Application by Sofia Offshore Wind Farm Limited under paragraph 2 of Schedule 6 to the Planning Act 2008 in accordance with the Infrastructure Planning (Changes to, and Revocation of, Development Consent Orders) Regulations 2011 for a non-material change to The Dogger Bank Teesside A and B Offshore Wind Farm Order 2015 (“the DCO”).

Statement of Common Ground between Sofia Offshore Wind Farm and the Marine Management Organisation

Dated: 20 November 2018

Figure 1: SOWF UWN modelling in relation to Flamborough Head spawning ground

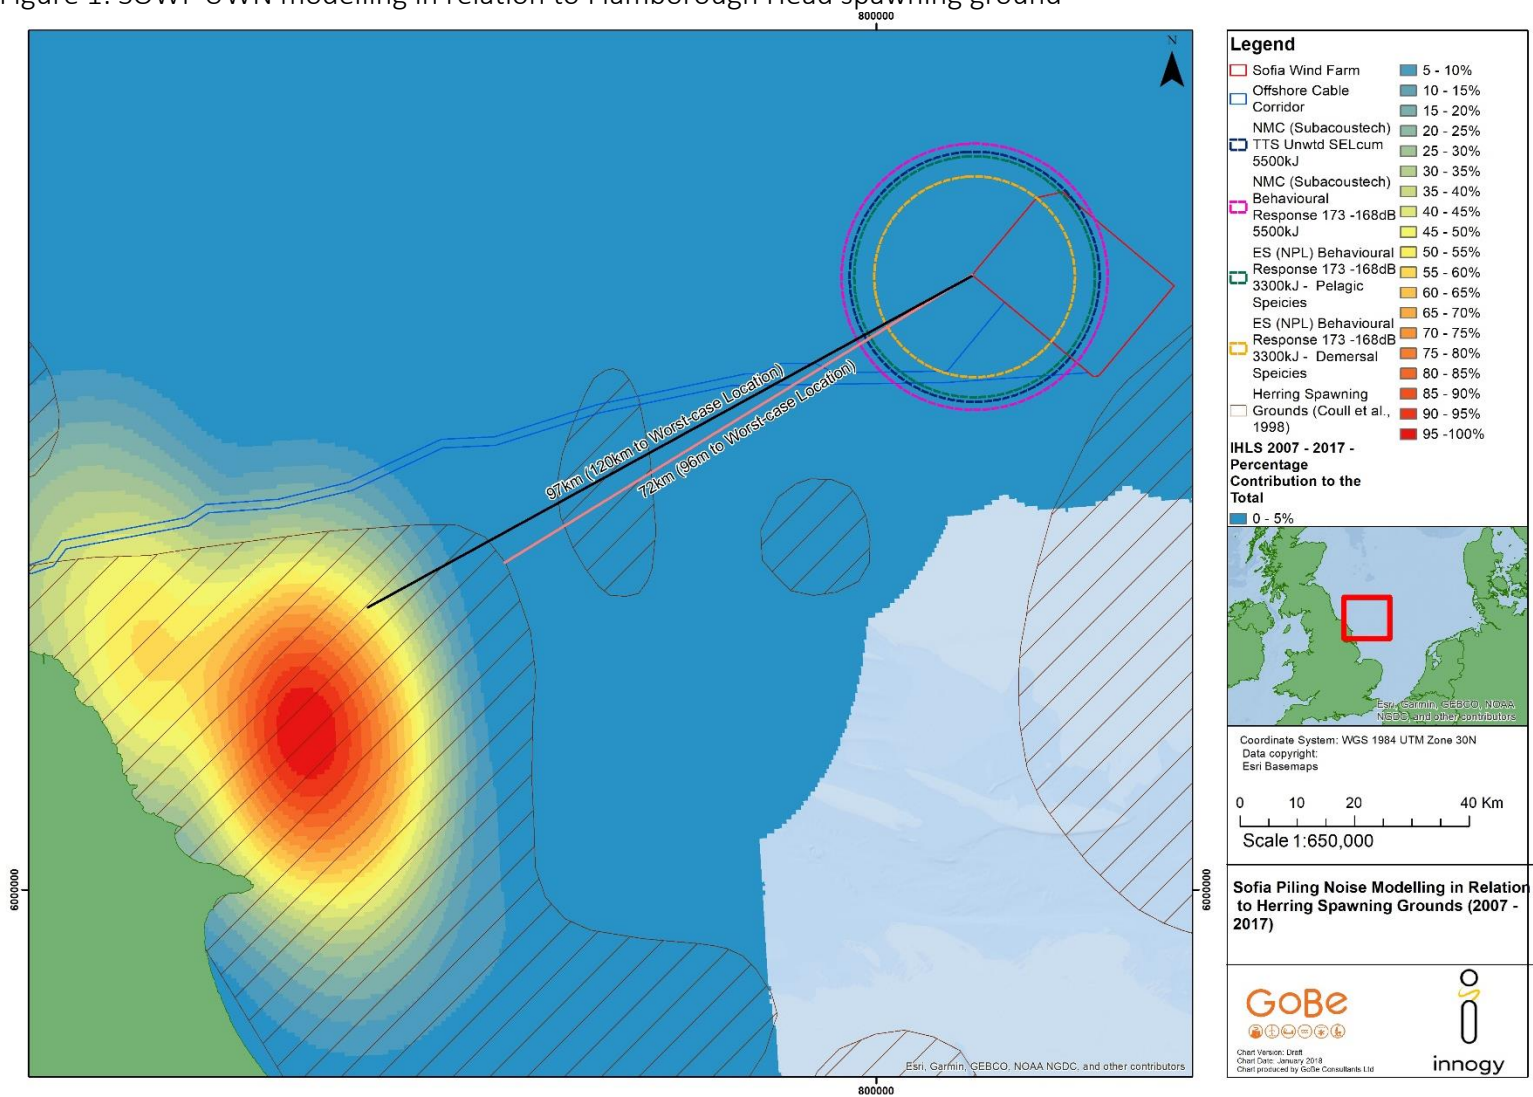
SOWFL understand that in the absence of a standardised contemporary approach to the assessment of behavioural effects of underwater noise from wind farm construction activity on fish receptors, the MMO and Cefas have sought further information to that provided by SOWFL as part of the NMC application. In their email of the 7 November 2018, the MMO requested further information specifically related to the effects of the increase in hammer energy to 5,500kJ on the Flamborough Head herring spawning ground, namely “modelling that is based on the predicted received single pulse Sound Exposure Levels at the spawning ground based on the 5,500kJ hammer energy”.

Before, discussing the latest modelled outputs, it is important to consider the context of the SOWFL wind farm array location in relation to the Flamborough Head spawning ground, and Figure 1 presents this further contextual information along with the original fish modelling outputs from the NMC application work.

For clarity, SOWFL confirm that the Flamborough Head herring spawning ground lies some **96km** from the closest point of the array based on the Coull et al (1998) data (and 72km from the furthest modelled behavioural response contour that was established within the NMC application assessment), and **120km** from the 50-55% spawning effort contour, based on the 10 year (2007-2017) International Herring Larvae Survey (IHLS) dataset (and 97km from the furthest modelled behavioural response contour).

As noted above, the closest point of the Flamborough herring spawning ground based on the more precautionary Coull *et al* data) to the array area is **96km**. This modelling has demonstrated that even when using criteria that is accepted as being unrealistically precautionary assumptions (in the case of the Hawkins criteria) and the further assumption that fish will remain static when exposed to noise, the distance of the spawning grounds remains significantly beyond any modelled theoretical impact range. It can therefore, be concluded with confidence that there is no pathway for behavioural effects from piling at SOWF to manifest on the Flamborough Head herring spawning grounds.
